Rudreshwara (Ramappa) Temple (India) No 1570

The Glorious Kakatiya Temples and Gateways -Rudreshwara (Ramappa) Temple, Palampet, Jayashankar Bhupalpally District, Telangana State, India

Consultations and Technical Evaluation Mission

Map showing the boundaries of the nominated property

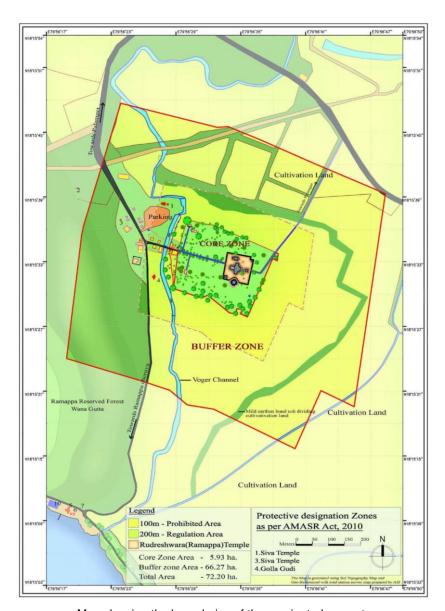
The nominated property has an area of 5.93 ha, and a buffer zone of 66.27 ha. The boundary of the nominated property corresponds to the area under the custodianship of the Archaeological Survey of India (ASI) and is physically marked by a fence. It contains the temples and the complex's outer wall and the immediate and small section of the landscaped garden surrounding it, which hosts some small visitor facilities.

The buffer zone is made up of the prohibited area and the regulated area, each drawn at 100m and 200m distance, respectively, from the boundary of the nominated property. Thus both areas together extend to 300 metres in every direction from the nominated property's boundary. The buffer zone encompasses mostly cultivated lands and forest in addition to three small-scale Kakatiya temples, the visitor parking spaces, and some commercial facilities at the entrance to the temple complex.

ICOMOS observes that the Rudreshwara temple complex is an integral part of a wider setting, which is historically shaped by Kakatiya *dharmic* tradition and composed of irrigation systems and water reservoirs which determined the exact location and enabled the functional use of the temple. ICOMOS notes the additional information provided by the State Party, which states that the temple was consciously located in a very specific location and set of natural features, surrounded by a water reservoir, channels and agricultural lands, which contributed to the merits of the temple establishment and were functionally linked to its

operation and economic basis. In ICOMOS' view, this larger environment of the temple, in particular the water storage and distribution system but also the forest reserve, agricultural fields and smaller temples, cannot be separated from the complex and contribute to the testimony of Kakatiya architectural and infrastructural development around Palampet. However, in the present nomination, these features are located outside the property boundary and buffer zone.

ICOMOS notes with appreciation that the State Party intends to establish a special development zone outside the buffer zone aimed at preventing inappropriate developments in a larger area. However, based on the additional information provided in response to ICOMOS' Interim Report, ICOMOS considers that important features are located in the buffer zone and also beyond it, in the area now intended to be designated as a special development zone. ICOMOS therefore considers that the State Party should consider a significant property boundary extension in order to ensure that all important features of the potential Outstanding Universal Value are subject to adequate legal protection and management, and that subsequently an extended buffer zone needs to be defined around the revised boundary delineation.

- Redefine the nomination approach to include the wider context of Rudreshwara (Ramappa) Temple and accordingly enlarge the property boundaries and buffer zone to include the architectural and engineering structures as well as natural features which form the historic dharmic context as well as the economic and functional basis of the temple;
